ADMINISTRATIVE AMENDMENT (PD) ADD2018-00062

ADMINISTRATIVE AMENDMENT
LEE COUNTY, FLORIDA

WHEREAS, KH Verandah LLC filed an application for an administrative amendment to a Mixed-Use Planned Development known as The Verandah for the following:

PROPOSED LAKE - PRESERVE - ORANGE RIVER
SECTION A–A
1" = 10'

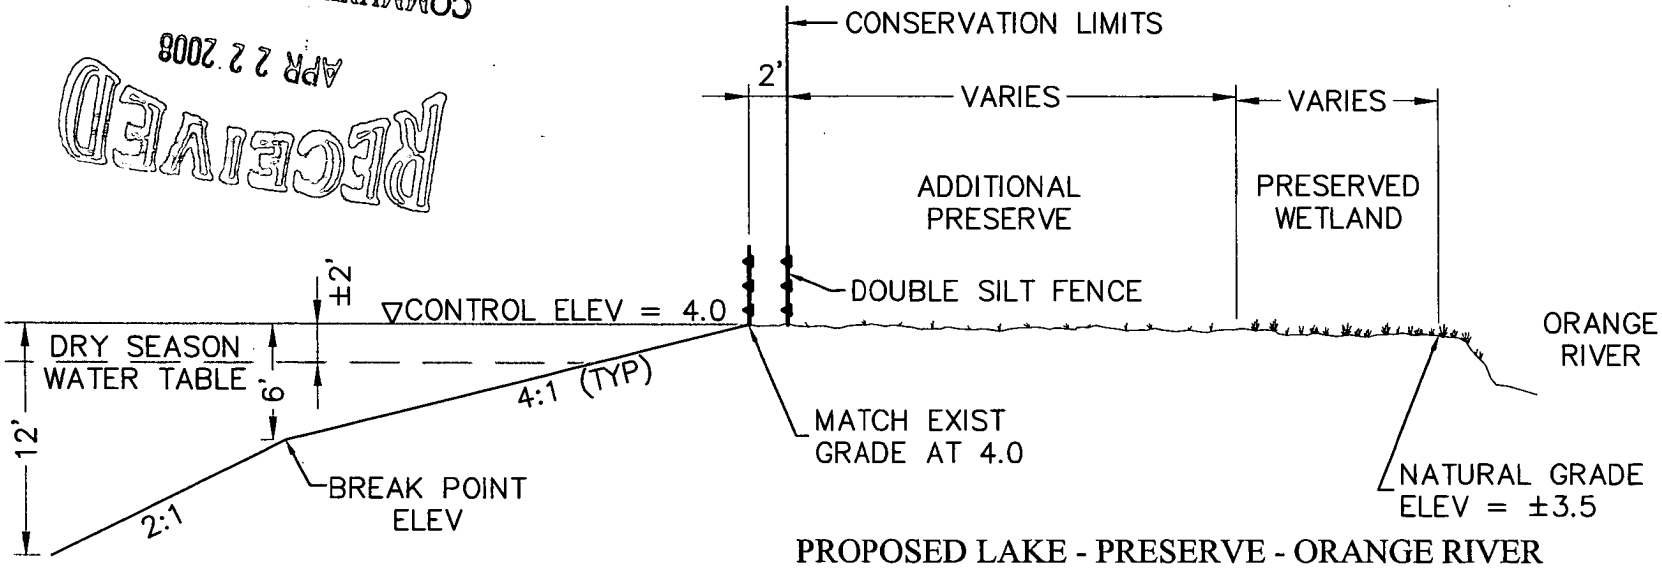
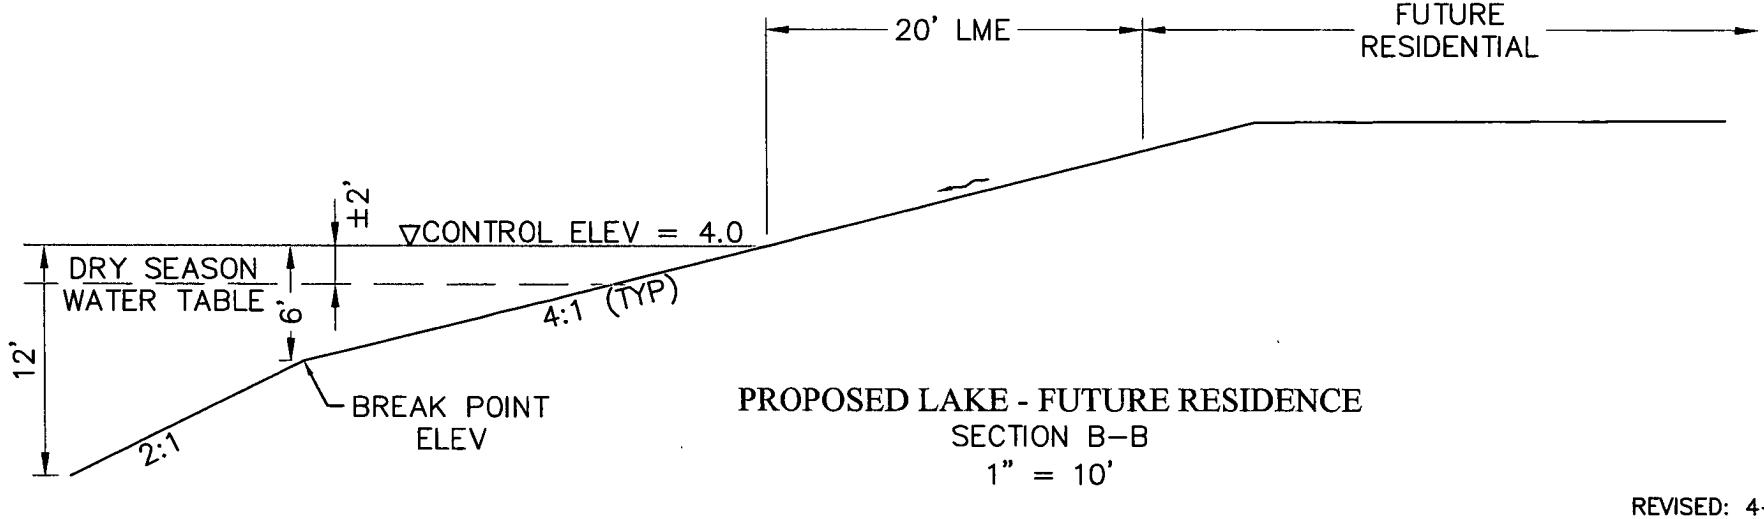
2. **Prior to local development order approval, the engineering plans must be in substantial compliance with Winding River Typical Lake Sections Exhibit "B" stamped received April 22, 2008 depicting a minimum 2 foot setback within the area labeled Lake B to the upland conservation limits and a maximum 12 foot lake depth to minimize excavation impacts.**

WINDING RIVER MASTER CONCEPT PLAN PARCEL 1-B OPTION 3

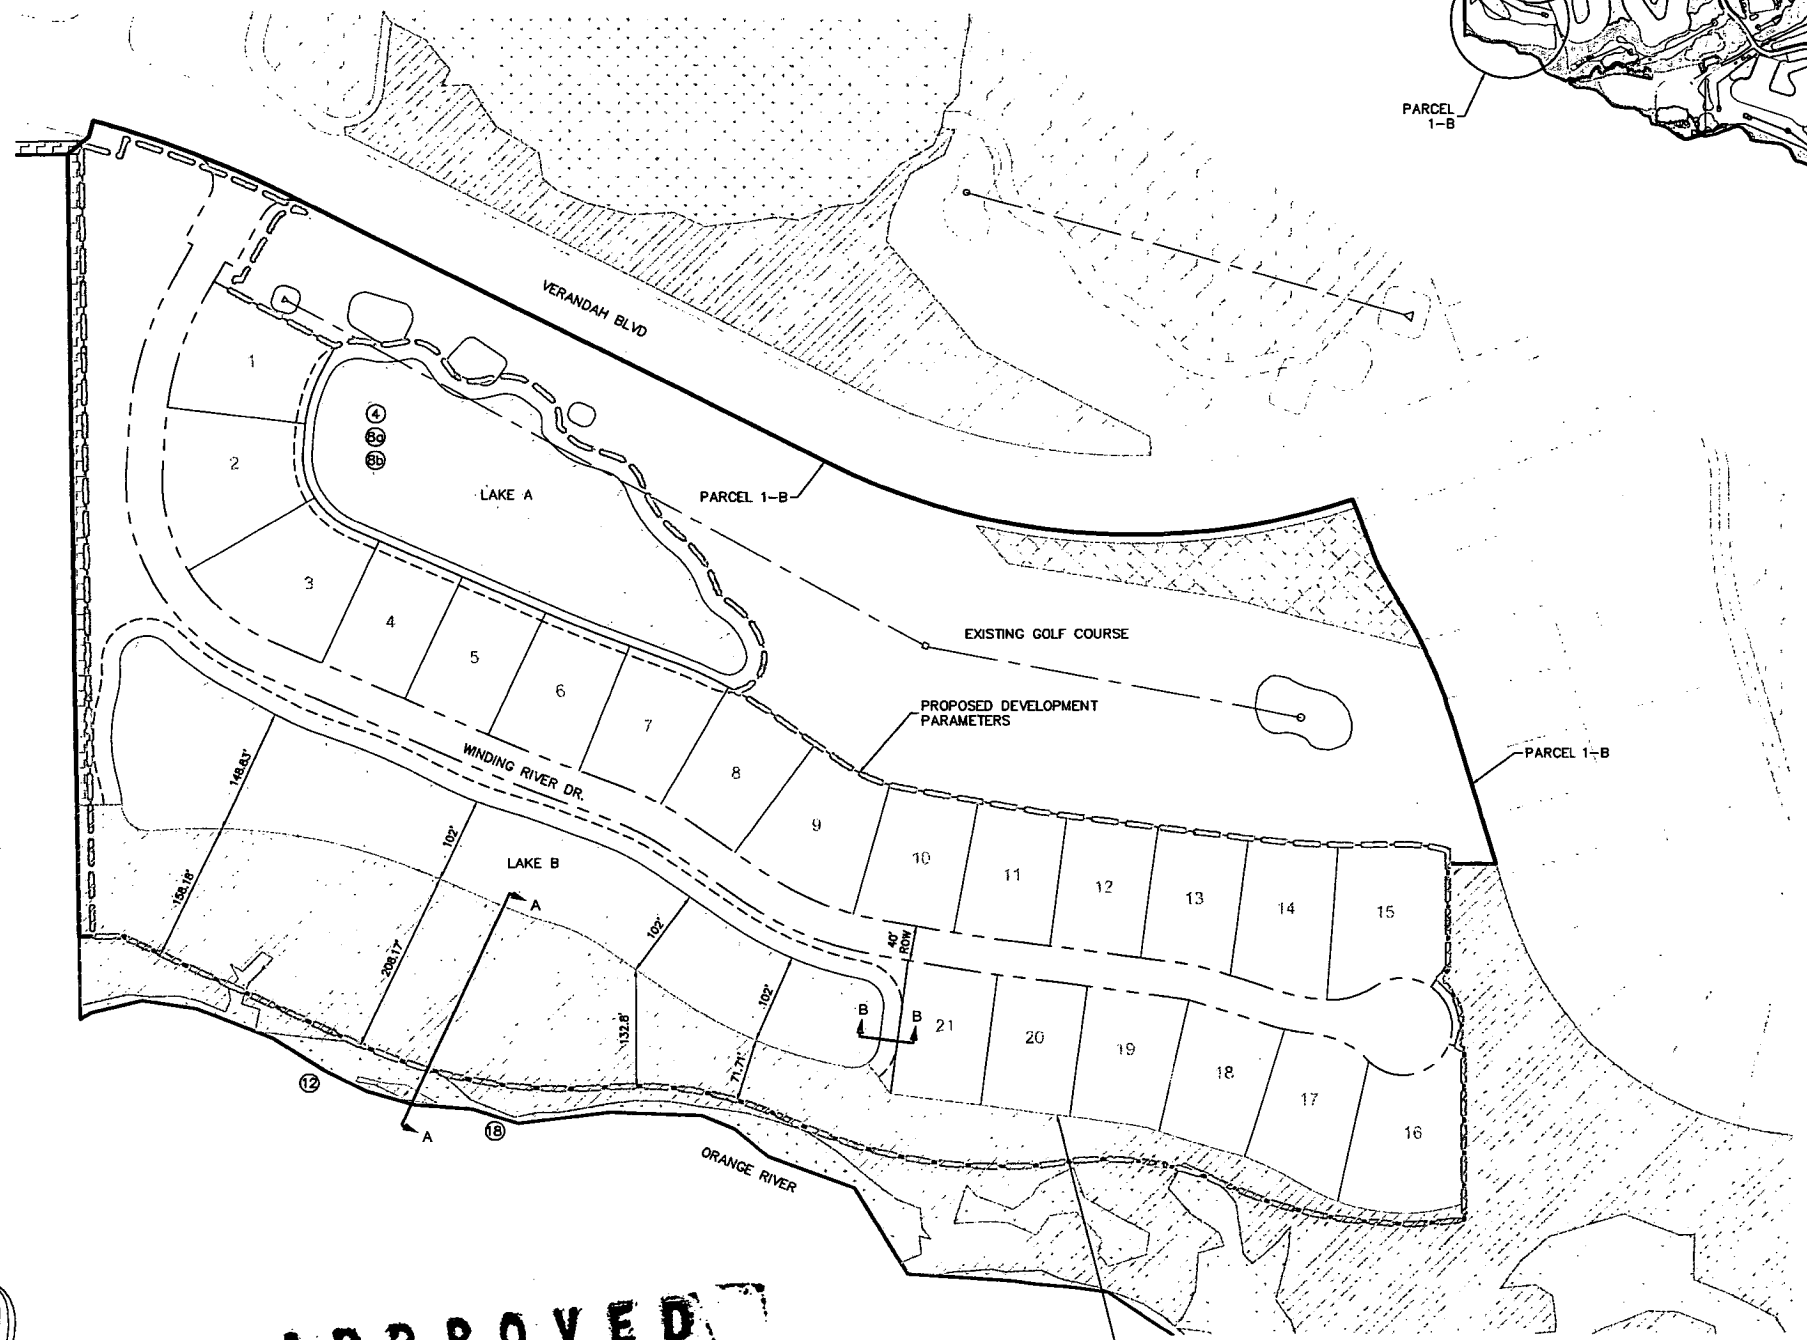
NOTE:
LOTS ON THE SOUTH SIDE OF WINDING RIVER DRIVE AND ABUTTING THE ORANGE RIVER ARE THE ONLY LOTS THAT WILL BE ALLOWED OBSERVATION DECKS.

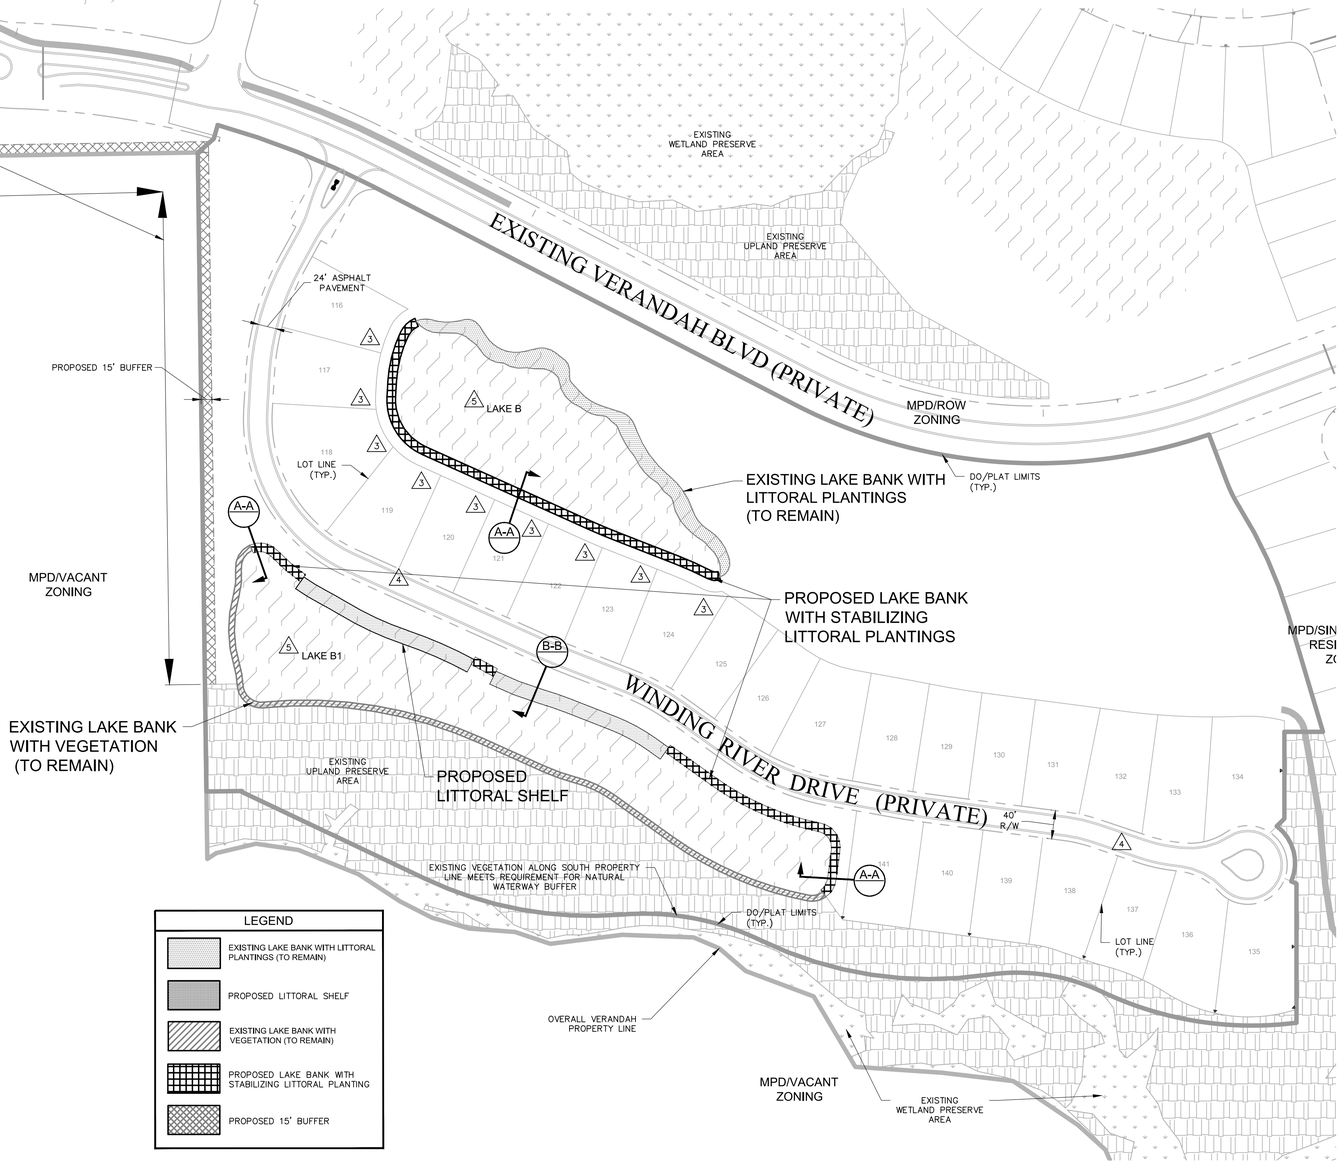
3. REQUEST TO REVISE THE PROPERTY DEVELOPMENT REGULATIONS TABLE APPROVED UNDER Z-05-081 TO ALLOW (SINGLE-FAMILY, ZERO LOT LINE, TWO-FAMILY ATTACHED, TOWNHOUSE AND DUPLEX) LOTS ABUTTING LAKES A 5' PRINCIPLE STRUCTURE REAR YARD SET BACKS AND A 0' ACCESSORY STRUCTURE REAR YARD SETBACK

5. DEVIATION FROM LEE COUNTY LDC SECTION 10-329(d)(4) WHICH REQUIRES THE BANKS OF EXCAVATION TO BE SLOPED AT A RATIO NOT GREATER THEN SIX FOOT HORIZONTAL TO ONE FOOT VERTICAL FROM THE TOP OF THE BANK TO A WATER DEPTH OF TWO FEET BELOW THE DRY SEASON WATER TABLE, TO ALLOW ALL LAKES REMAINING TO BE CONSTRUCTED WITHIN THE OVERALL VERANDAH DEVELOPMENT USING A 4:1 SLOPE AND ADDITIONAL LITTORAL PLANTINGS.
